Access Compliance Report Public Rights-of-Way (Curb Ramps)

Intersection ID: 46590 Main Street: QUAKING_GRASS_CT Cross Street: RABBITS_FOOT_LN Location: N

ADA ID: E6AC5277DFB5 Ramp Type: BlendTrans2 Initial Pass/Fail: Fail Overall Compliance: No Severity Score: 33.75

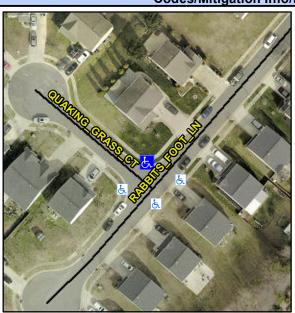
Not Found, R304.5.1, R304.5.3

Field Measurements/Component Compilance					
Compliance Description		Data	Compliance Description		Data
N/A	Ramp Length (in)	95.0	Yes	BlendTrans Slope (%)	4.0
No	Ramp Width (in)	36.5	No	BlendTrans XSlope (%)	11.7
N/A	Flare Type LT	N/A	N/A	Flare Type RT	N/A
N/A	Flare Slope LT (%)	N/A	N/A	Flare Slope RT (%)	N/A
N/A	Flare Traversable LT?	N/A	N/A	Flare Traversable RT?	N/A
N/A	Landing Length (in)	N/A	N/A	DWS Provided?	N/A
N/A	Landing Width (in)	N/A	N/A	DWS Contrast?	N/A
N/A	Landing Slope (%)	N/A	N/A	DWS Length (in)	N/A
N/A	Landing X Slope (%)	N/A	N/A	DWS Full Width?	N/A
N/A	Landing Curb? (Y/N)	N/A	N/A	DWS Offset (in)	N/A
N/A	Shared Landing?	N/A			
N/A	Gutter Ponding?	N/A	N/A	Gutter Slope (%)	N/A
N/A	Gutter Lip Ht (in)	N/A	N/A	Gutter X Slope (%)	N/A
N/A	Painted X Walk1?	No	N/A	Painted X Walk2?	No
	X Walk 1 Direction	To SW		X Walk 2 Direction	To SE
	X Walk 1 Width (in)	N/A		X Walk 2 Width (in)	N/A
	X Walk 1 Slope (%)	2.8		X Walk 2 Slope (%)	6.4

Remove & Replace Curb Ramp With Two New Directional Ramps or Equivalent.
